**City of Mesa -
Administrative Review**
Cityview cases ADM23-00243 and ADM23-00254

Re-Submittal of Corrections:

- Loading Dock Elevation Windows,
- Overhead Door Canopies,
- Panel "Arch" Relief

Germann Industrial Park

EXTERIOR
ELEVATIONS
BUILDING E

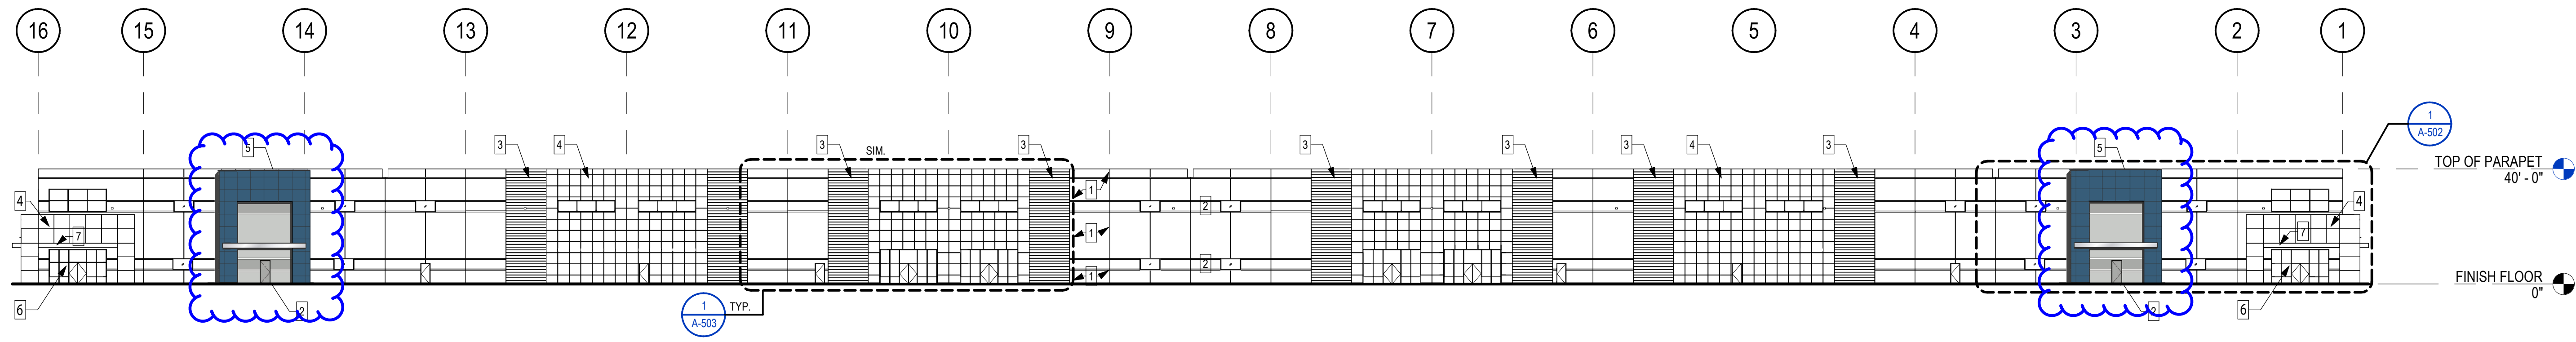
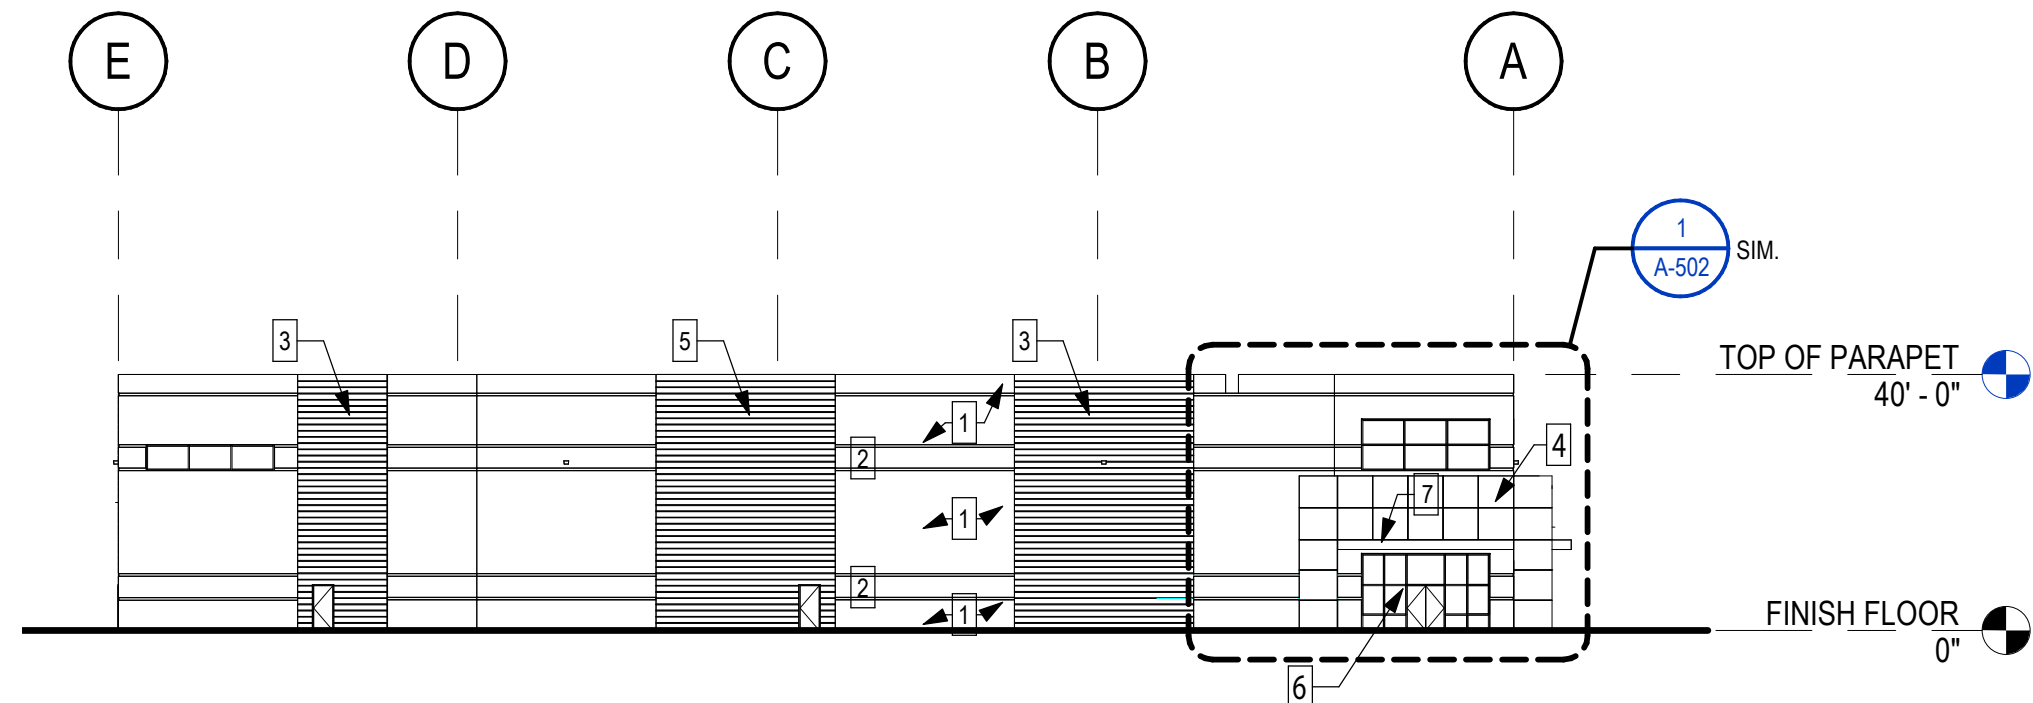
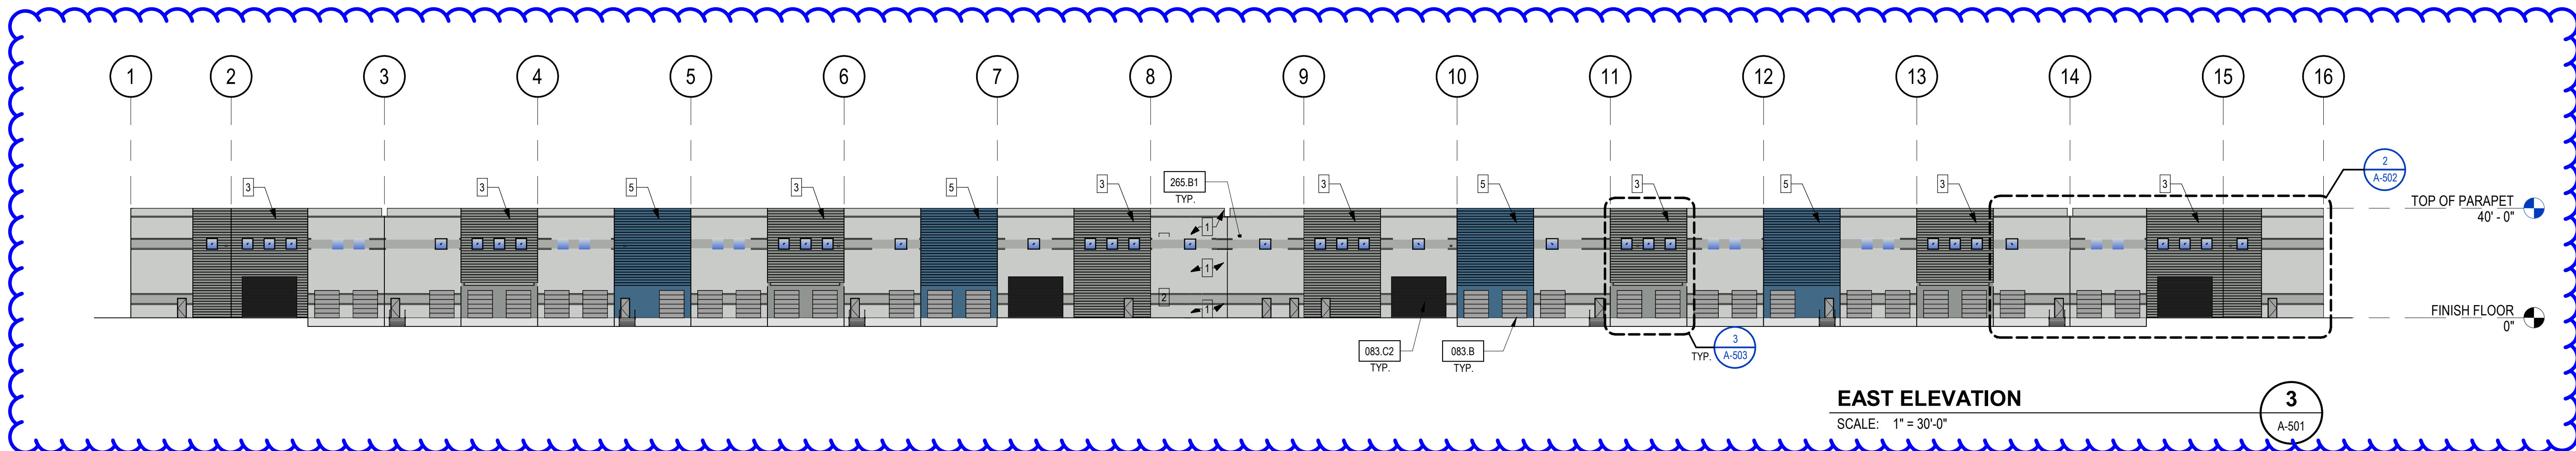
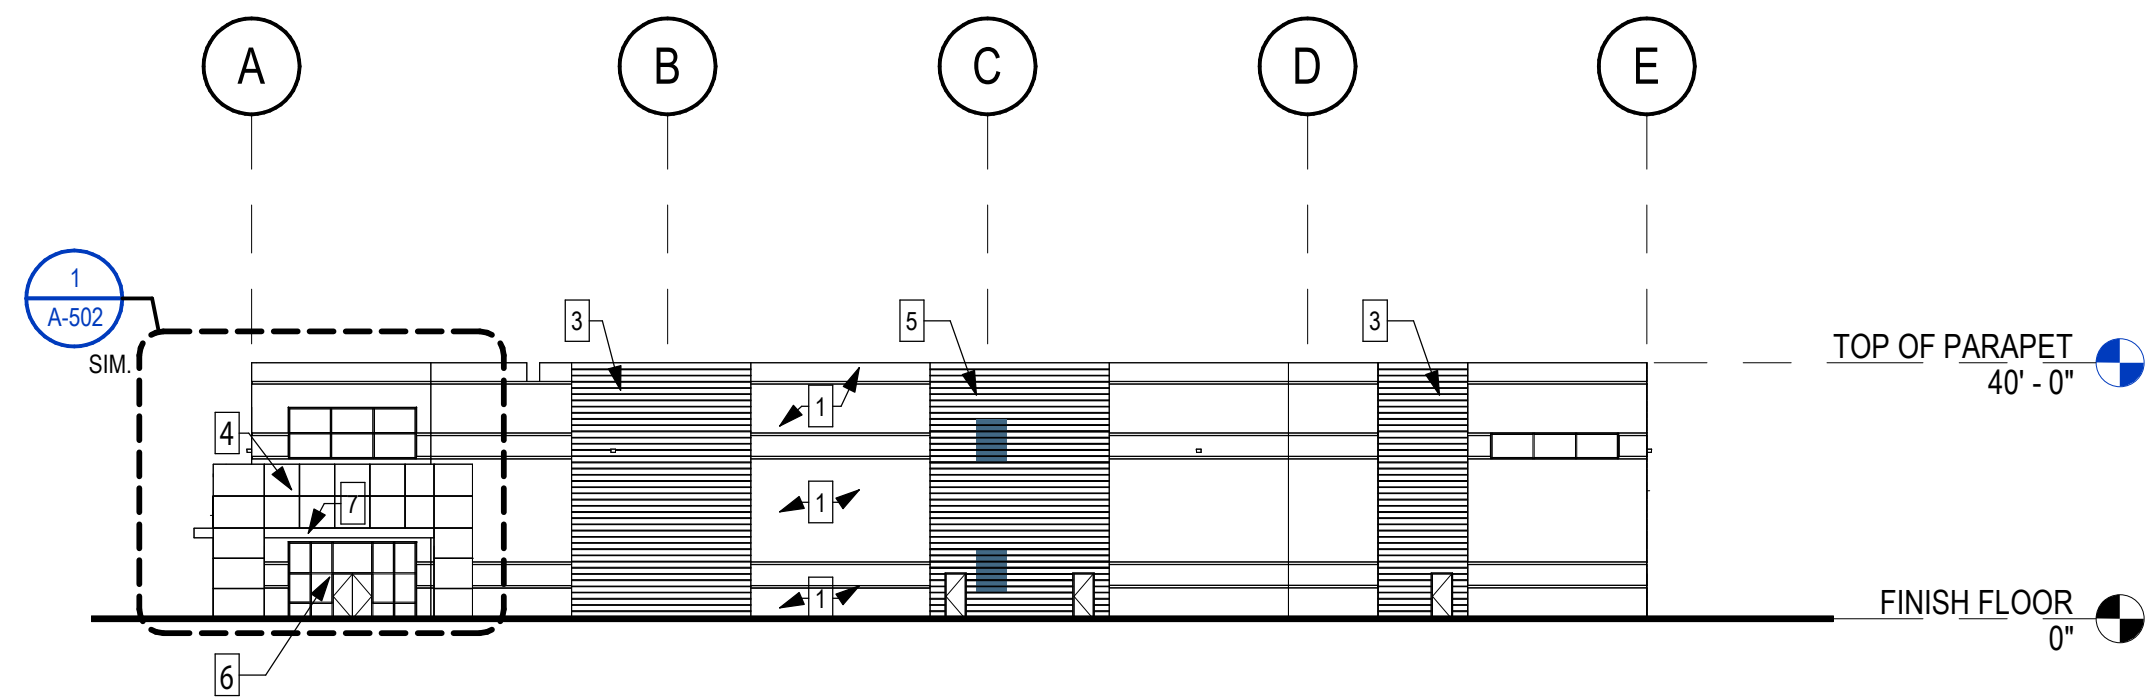
Re-Submission of Corrections:
- Loading Dock Elevation Windows,
- Overhead Door Canopies,
- Panel "Arch" Relief
6/29/23
